# Packing tray change notice

From: NIDEC COMPONENTS CORPORATION

Title : Packing tray change notice

[Applicable model]  
All types of MG16B

Comparison of old and new packaging methods(MG16)

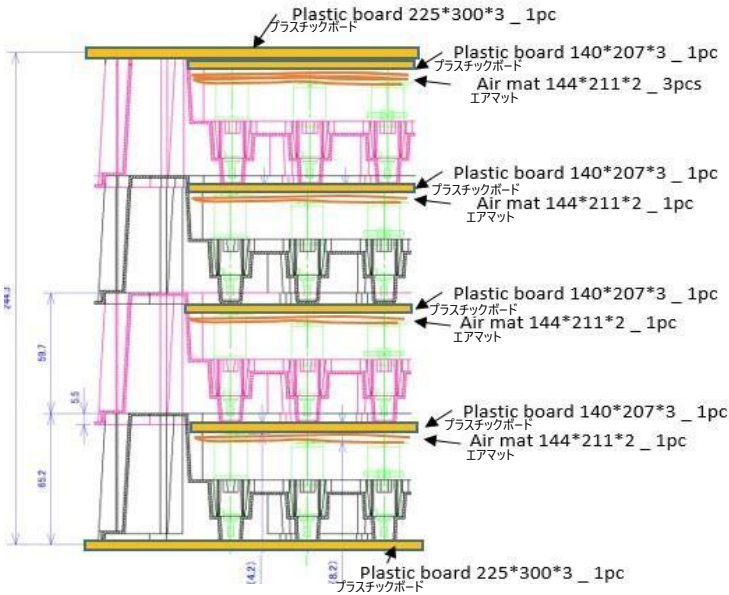
Our MG16 series is shipped in a styrofoam tray.

However, foam trays are difficult to obtain at overseas factories, and from an environmental point of view, they have a large volume when discarded and are not suitable for recycling.

For this reason, we plan to change to a general plastic tray.

In addition, as a result of the evaluation of packaging vibration and drop, there was no problem with the characteristics even after changing the packaging.

After changing

Plastic tray 30pcs/tray × 4layers × 2packs = 240pcs / carton
